AGENDA
Regular Hybrid Meeting
Town of Granby
Planning & Zoning Commission
Tuesday, June 24, 2025, at 7:00 pm
Town Hall Meeting Room

RE: Application seeking a Site Plan and Special Permit under Zoning Regulations Sections 3.5.4.3, 8.6.14 and 8.21.4 for a commercial building in the Aquifer Protection Overlay Zone with an illuminated freestanding directory sign and outdoor storage, for property located at 14 Mill Pond Drive, C2 Zone: File Z-7-25.

Site Plan Review

Plan: "Proposed Commercial Facility, #14 Mill Pond Drive, Granby, Connecticut 06035, May 2, 2025, Biff Schechinger, Landscape Architect, Revised 4 June 2025, marked up copy revised 6/18/2025."

DRAWN BY:	CHECKED BY:	JOB NO.	SHEET No.
GRA	JPM	21-14	S.1

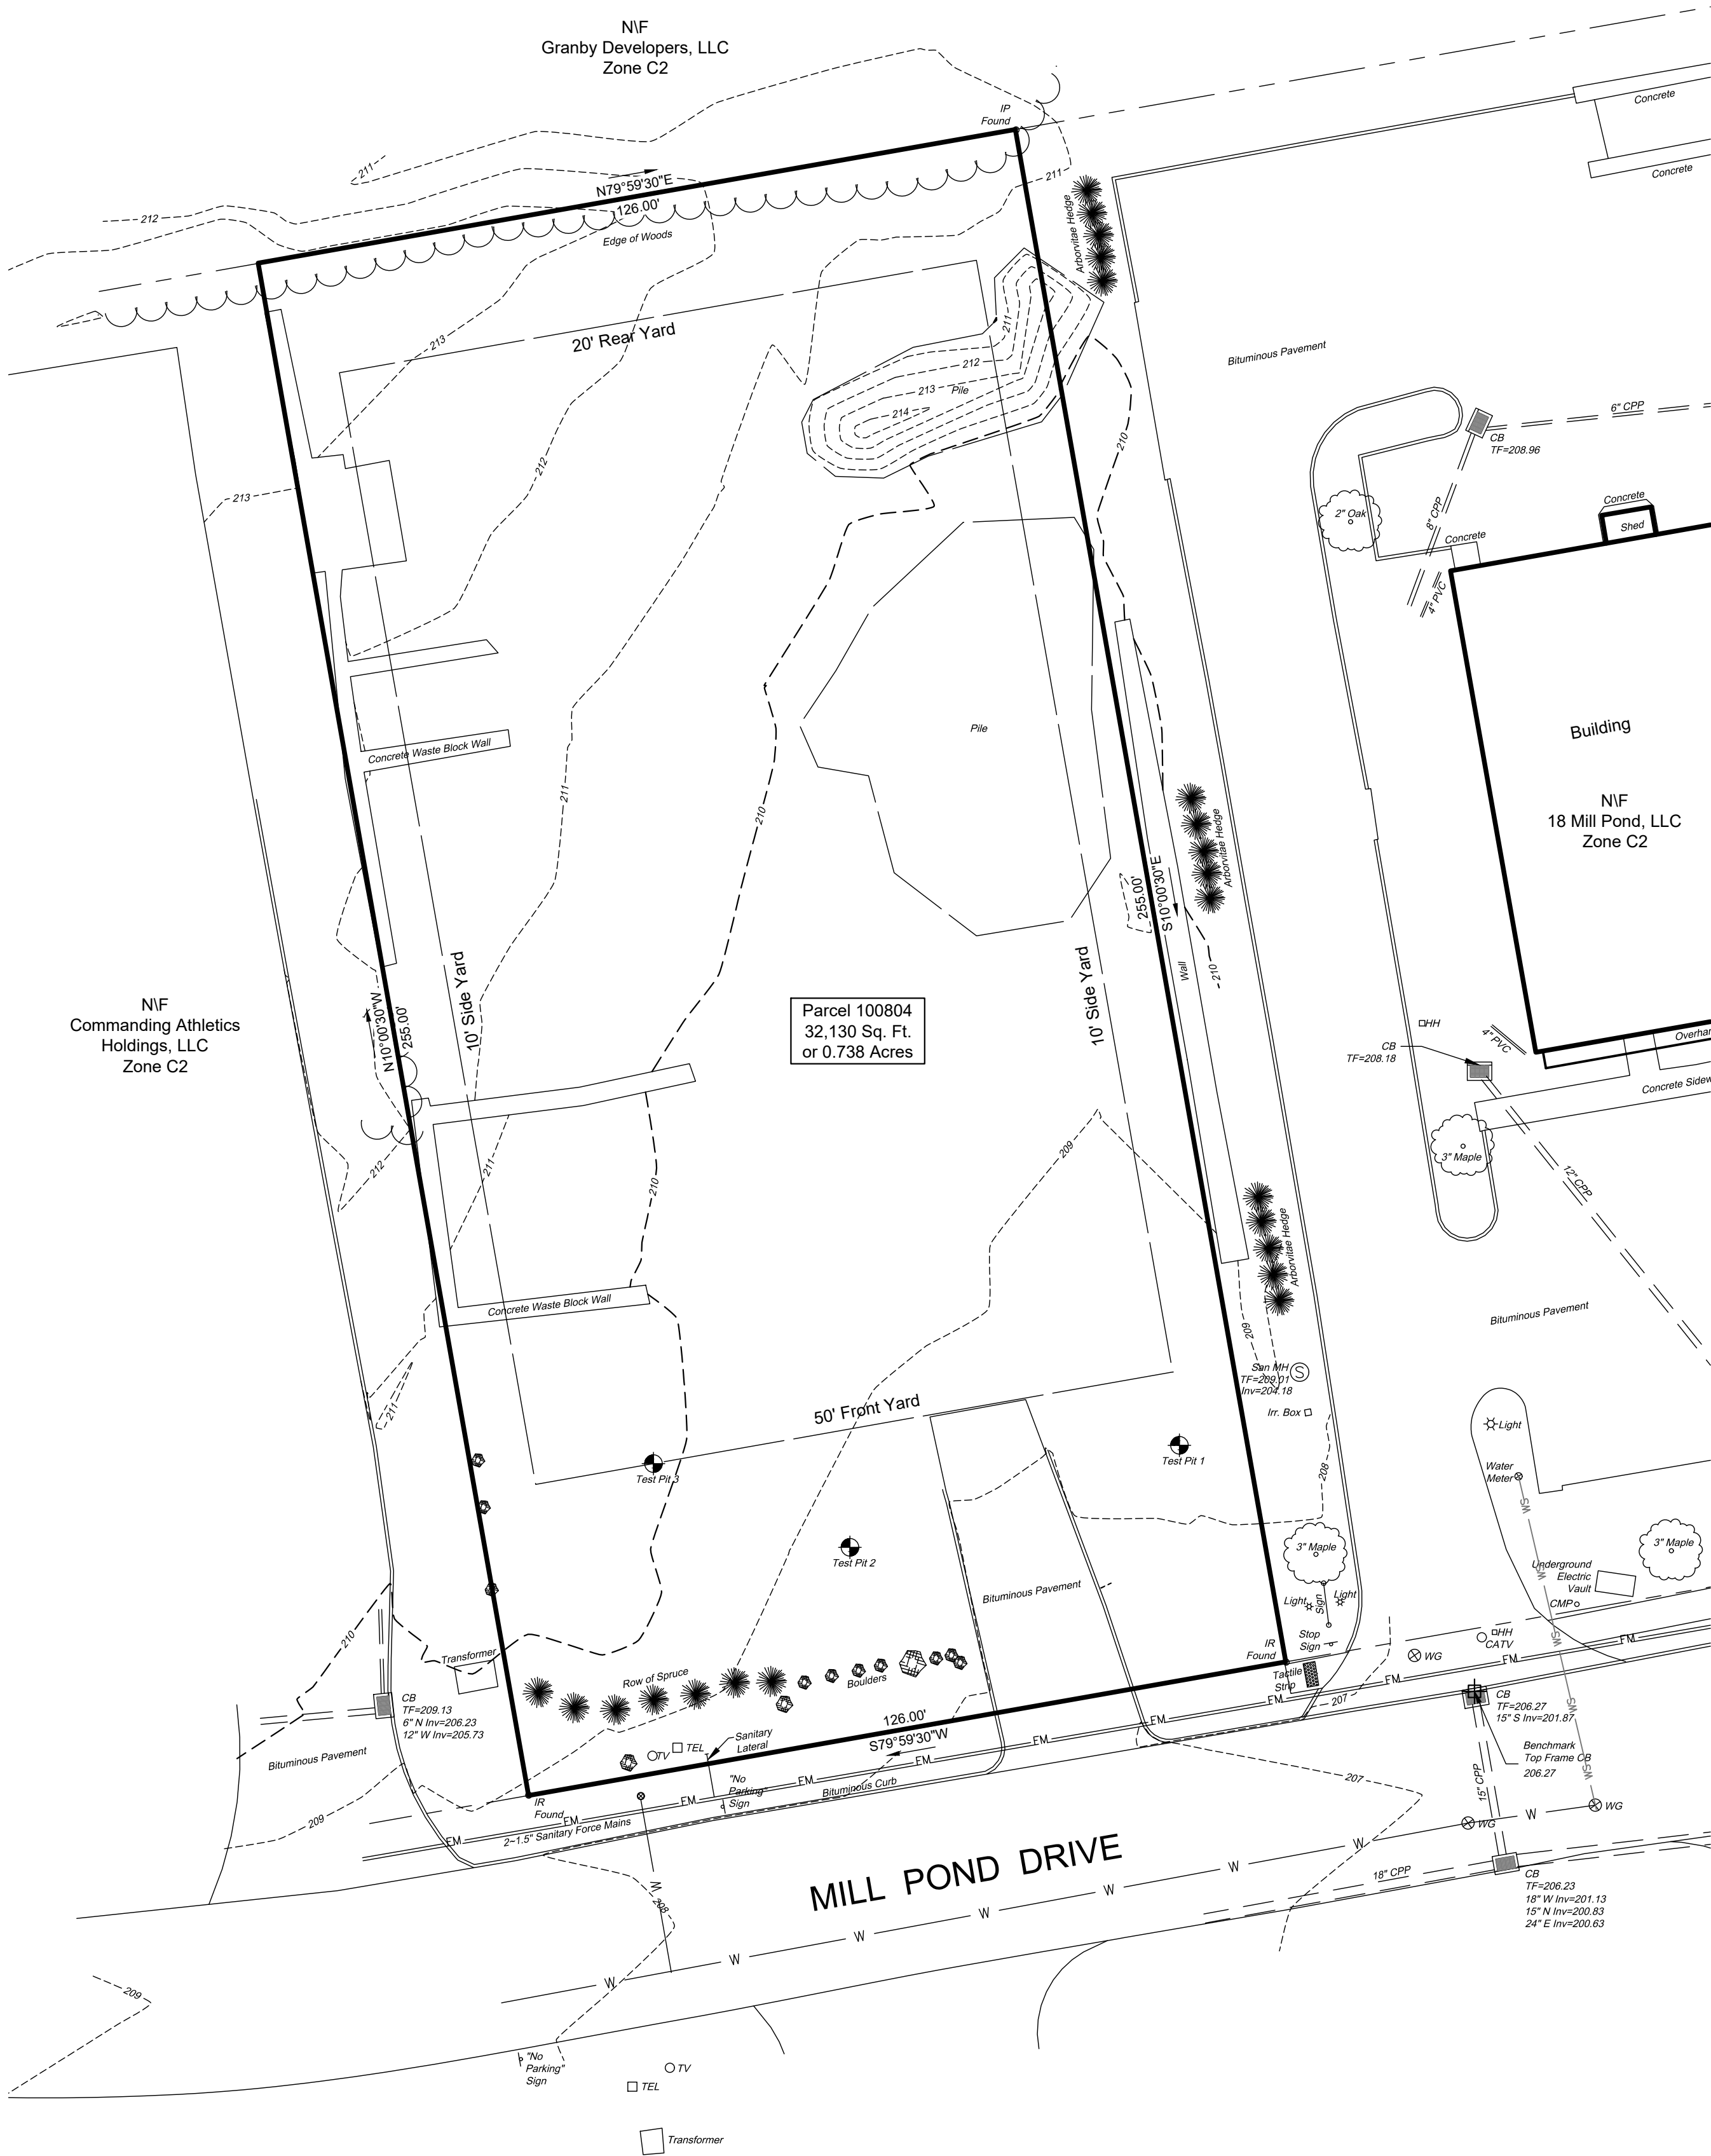
4. Show a benchmark with datum.
